Project: E.L. Miller ES - Facility Improvements Project No: 354-35
 Contractor: Centennial Contractors Architect: CDH Architects
 Originator: Ryan Fernandez Date: April 10, 2024

**THE DEKALB COUNTY BOARD OF EDUCATION
CONSTRUCTION CONTRACT CHANGE ORDER**

Project Name:	E.L. Miller ES – Facility Improvements
Project No.:	354-423
Change Order No.:	03
Date:	April 3, 2024

E.L. Miller ES
Change Order No. #3 - Breakdown

SHEET NUMBER
A100

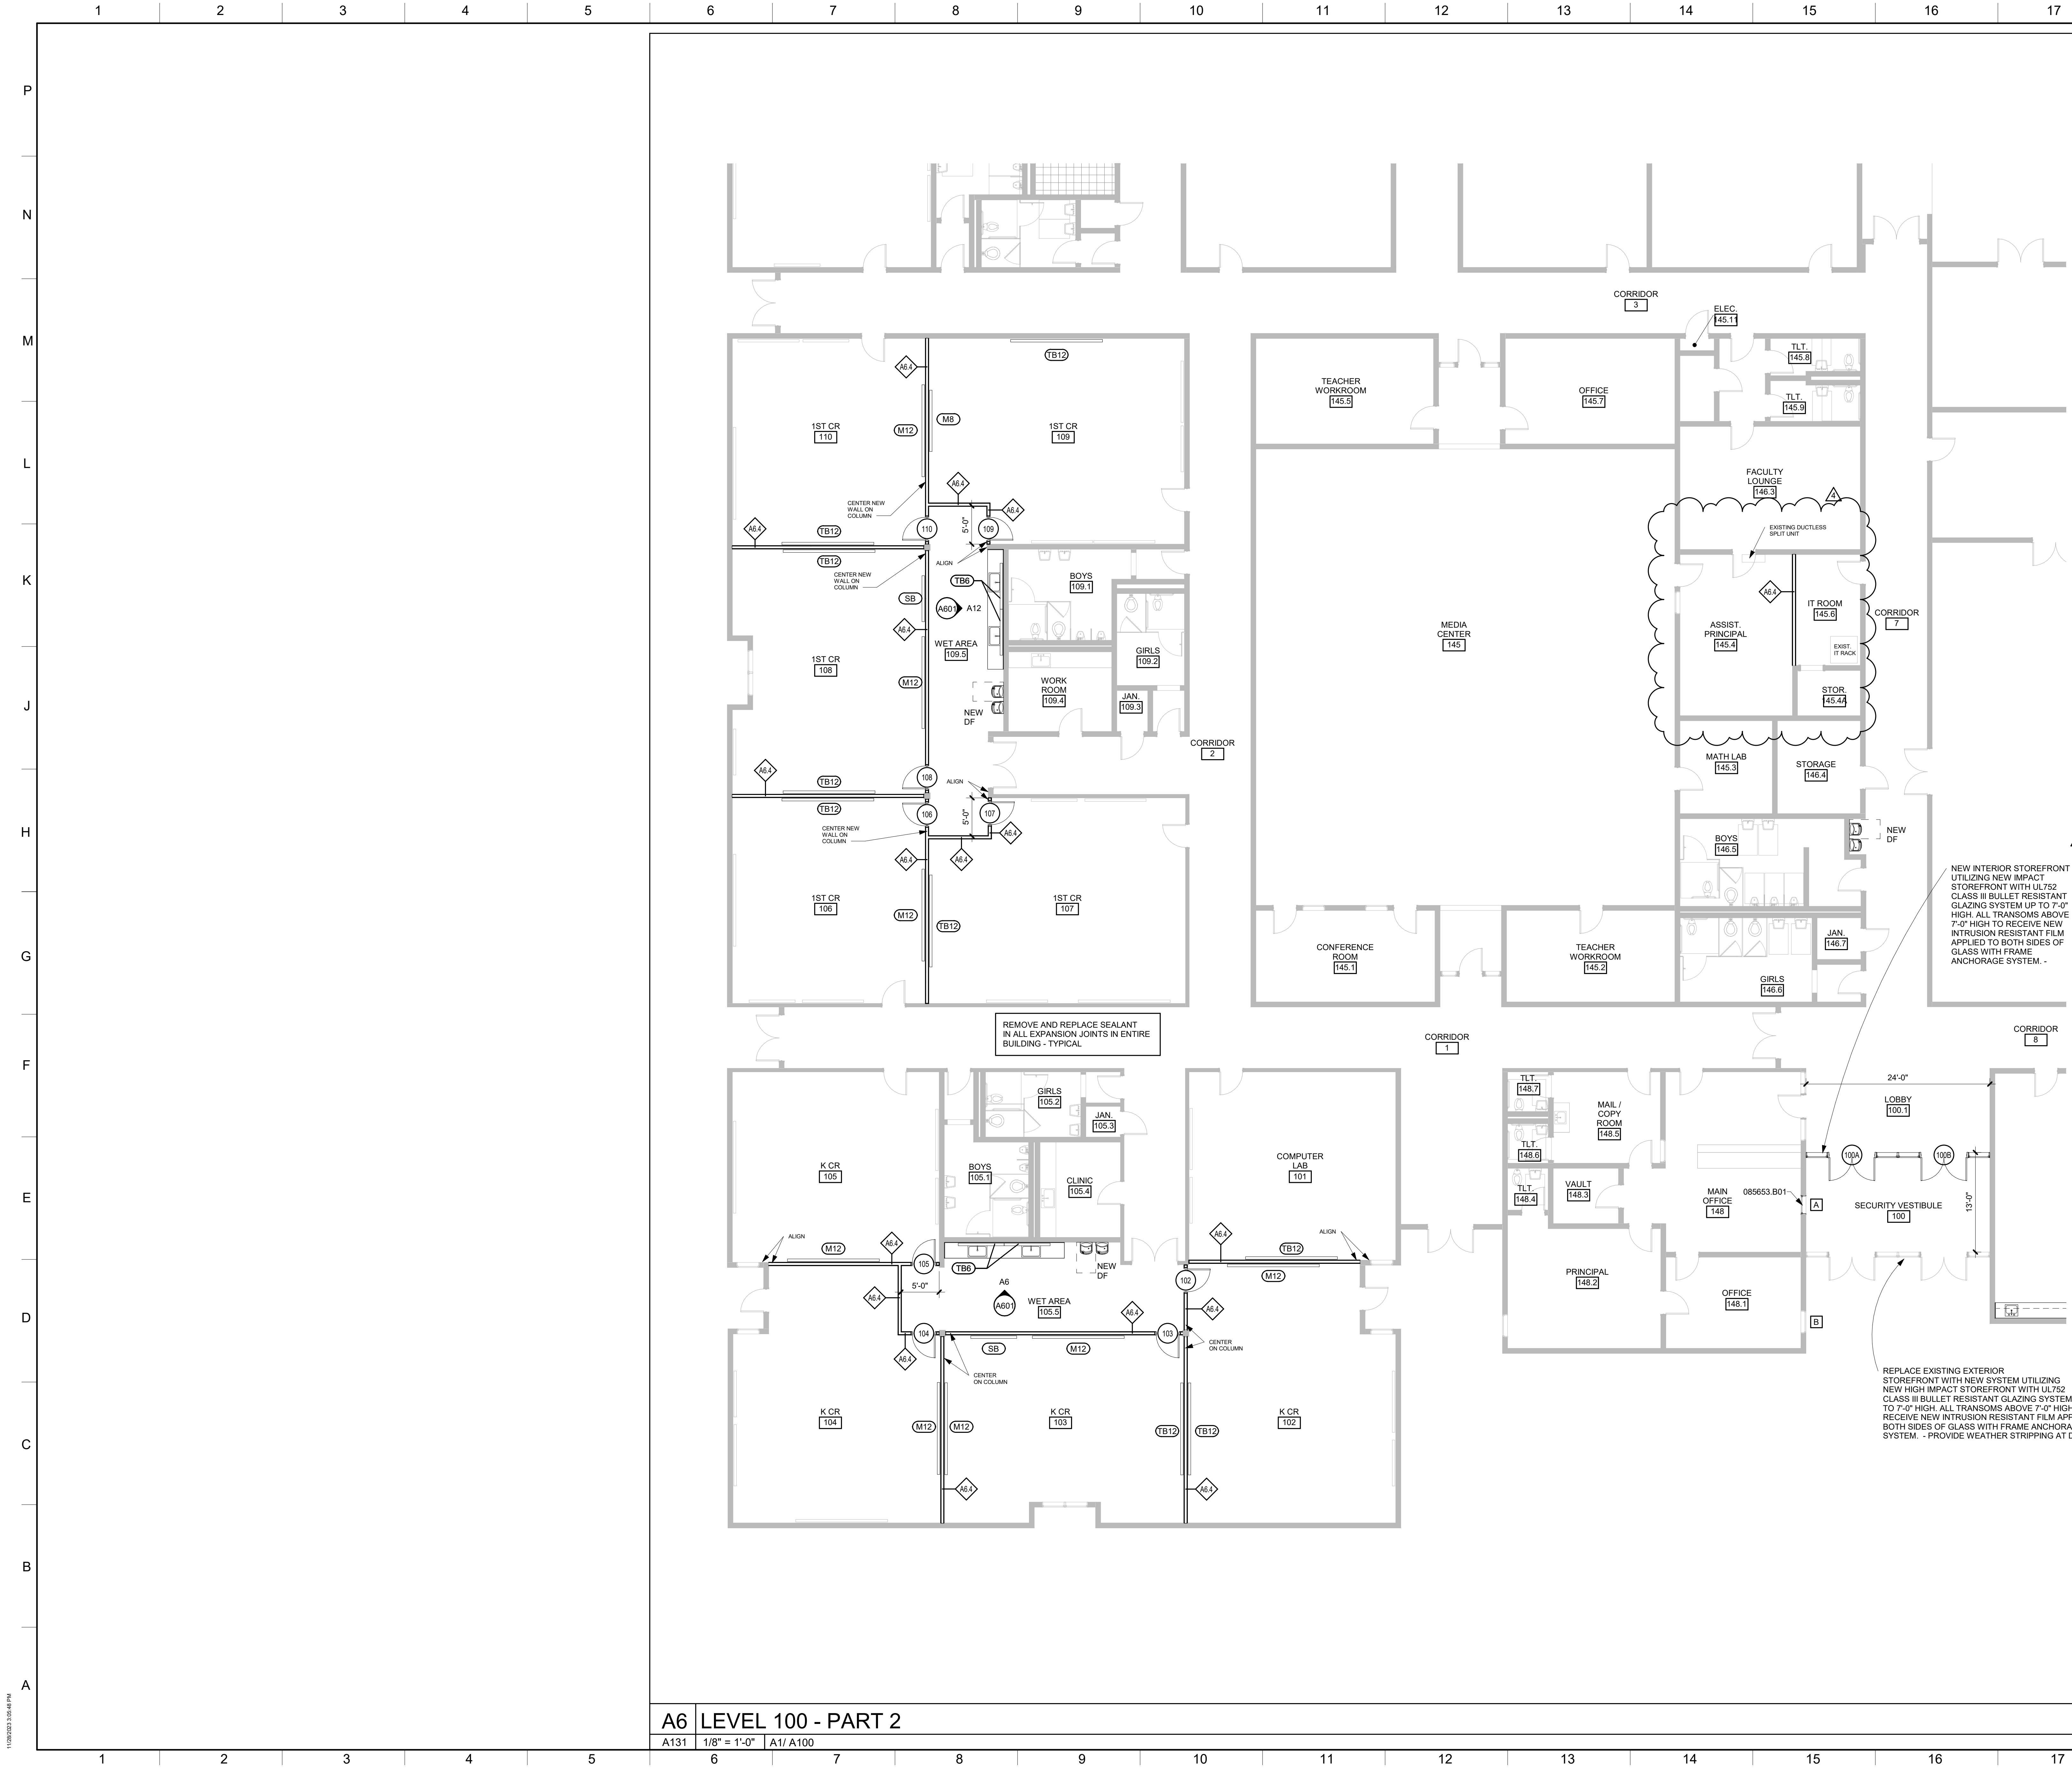
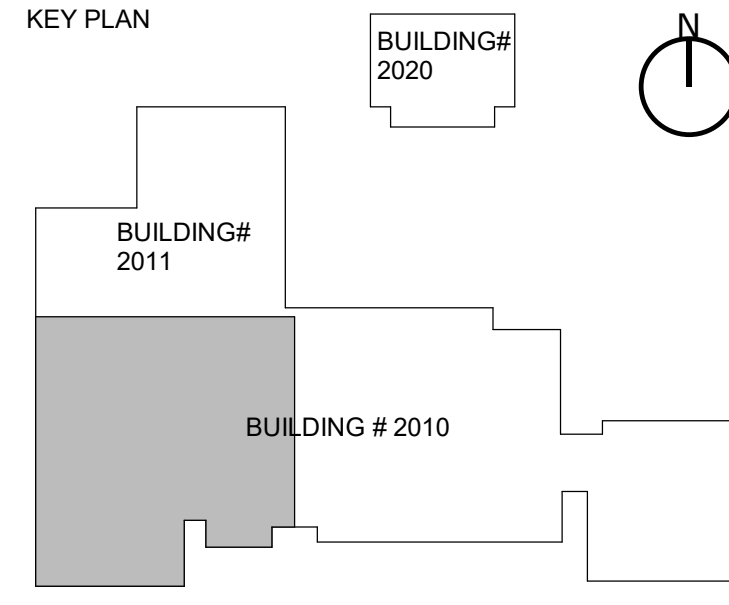
Separate room 145.4 and room 145.6 to create a separate IT Room for the DCSD IT rack based off drawings EL Miller IT Room Revision 4 provided by CDH Architecture. This includes a new ductless split system for Room 145.6, a new gypsum board partition to deck above, relocating fire suppression is necessary, along with incidental painting and flooring repairs. Reference RFI #49 and drawings E.L. Miller IT Room Renovations 4 that are attached.

12/04/2023	
4	Rev 6 IT Room

SHEET TITLE
ENLARGED PLANS
 SHEET NUMBER
A131

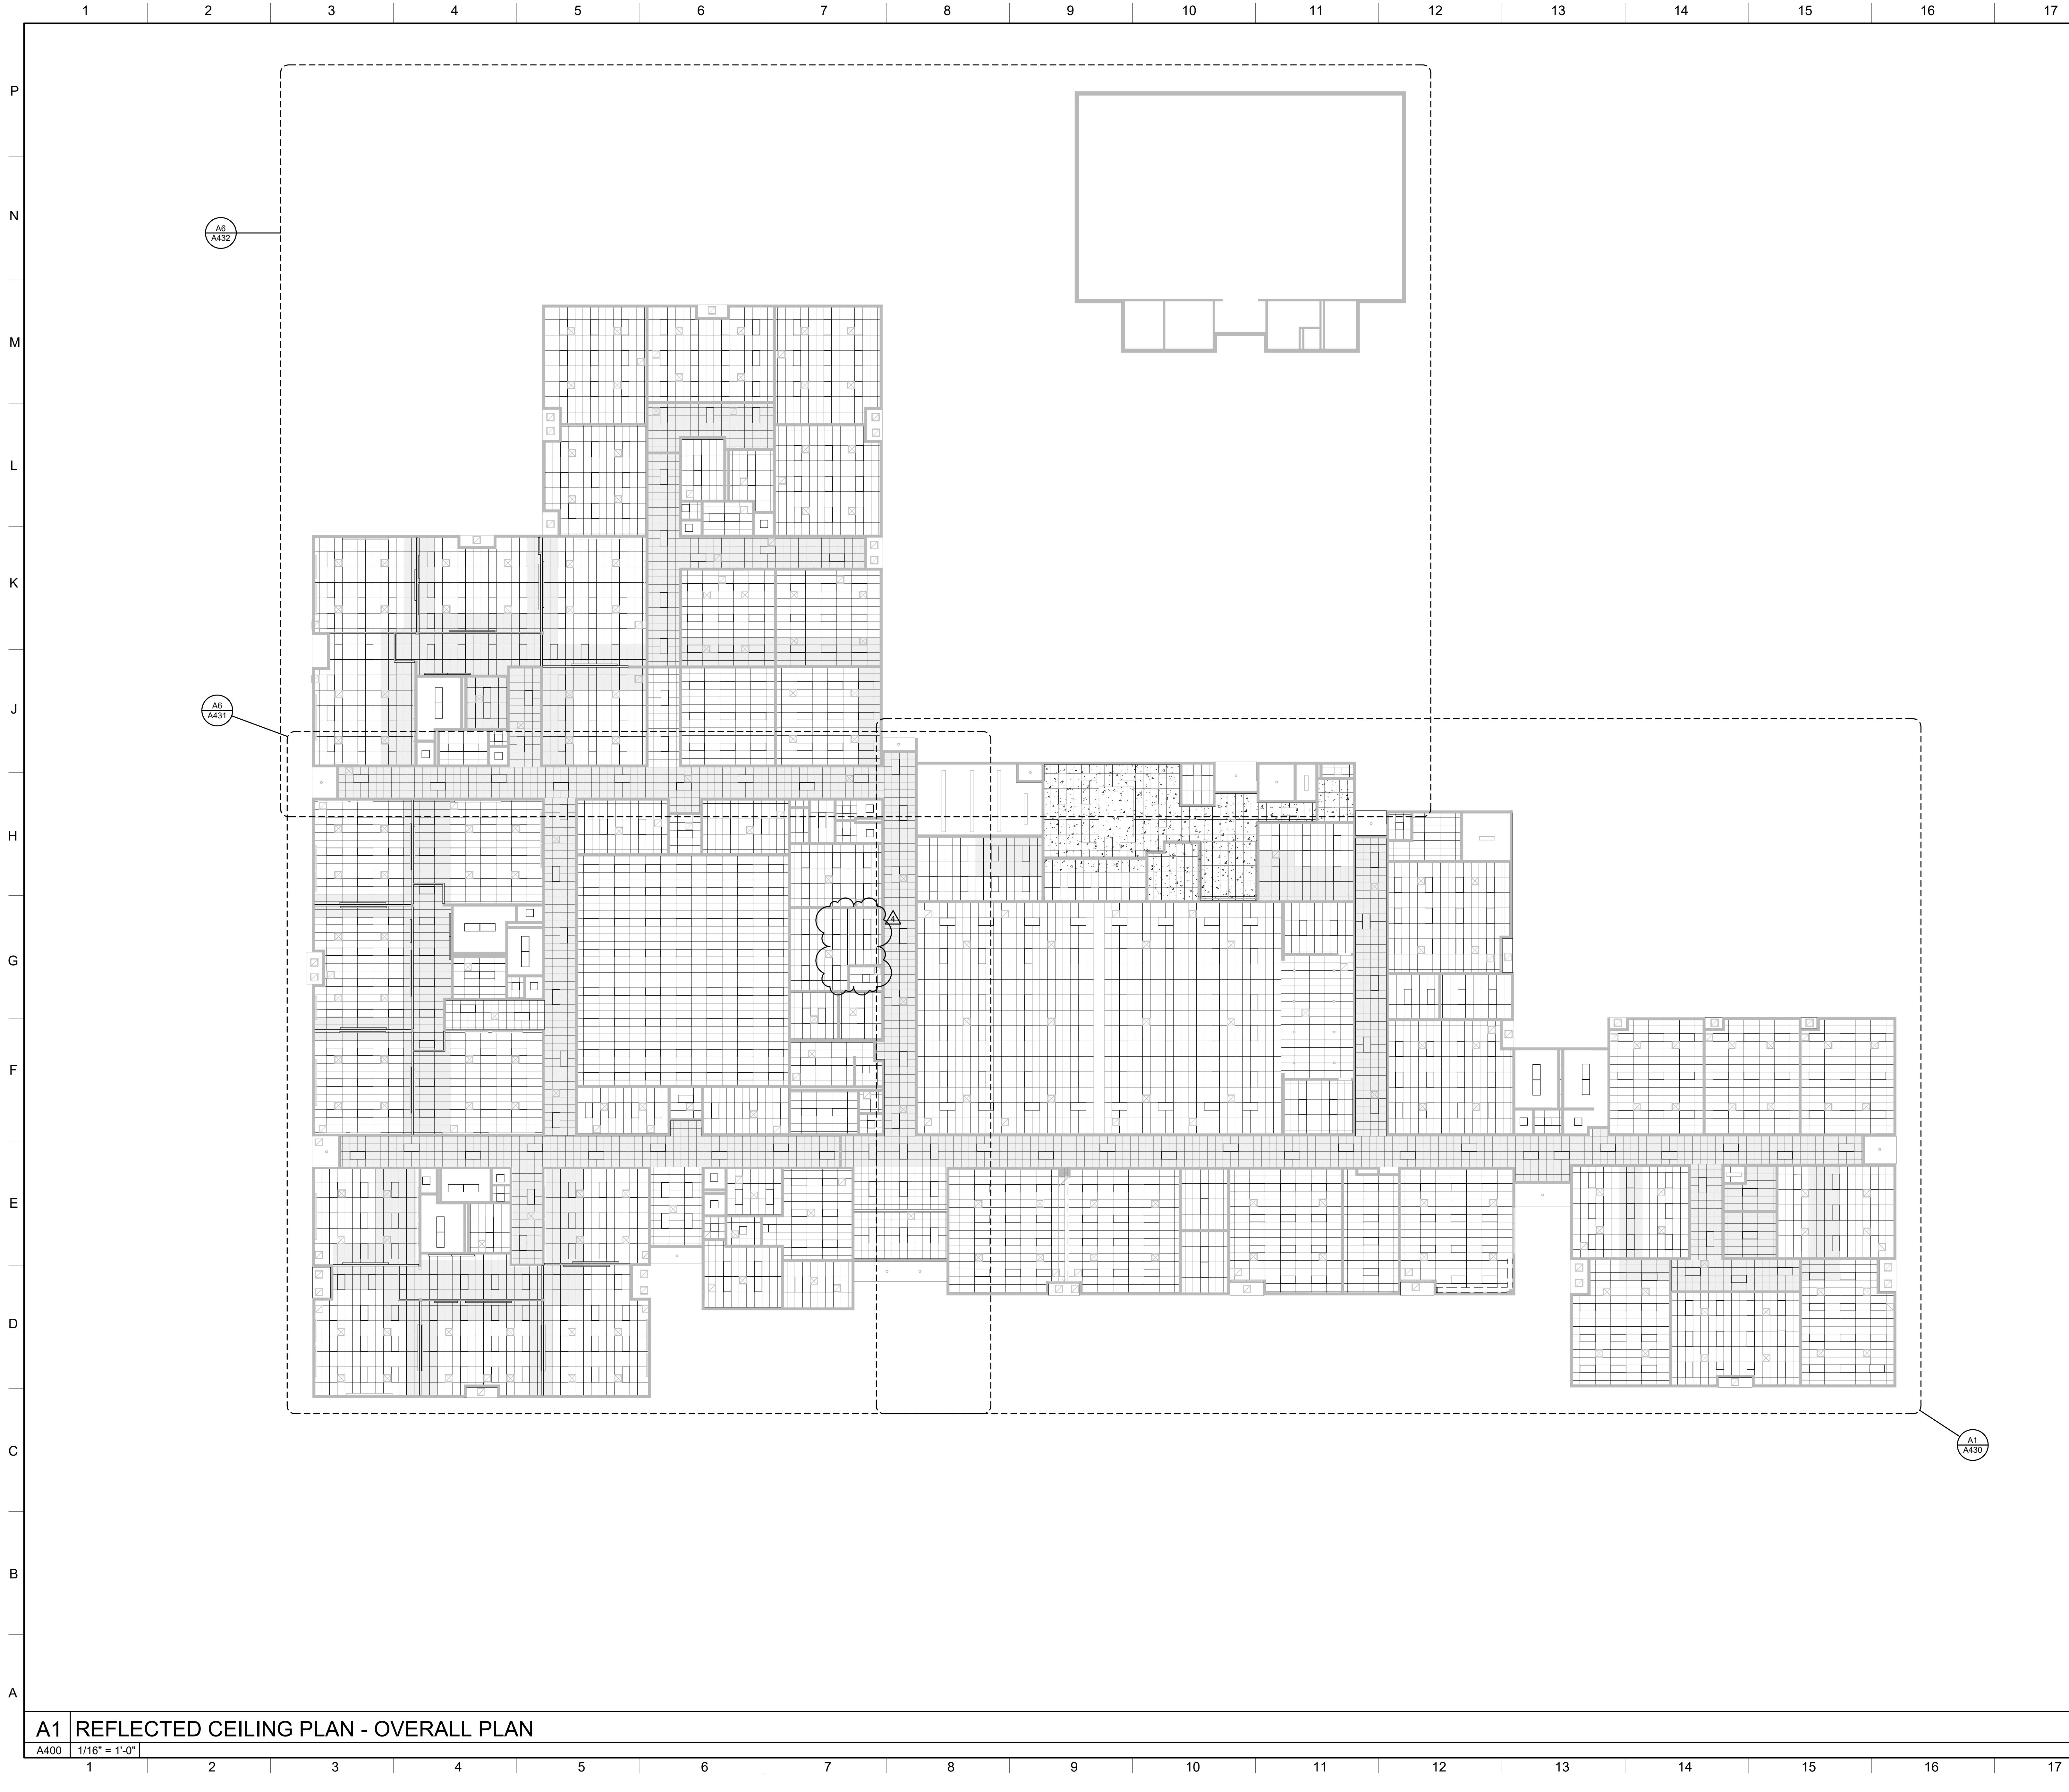
6-08-2022	12-04-2023
B	ADDENDUM NO. 2
4	Rev 6 IT Room
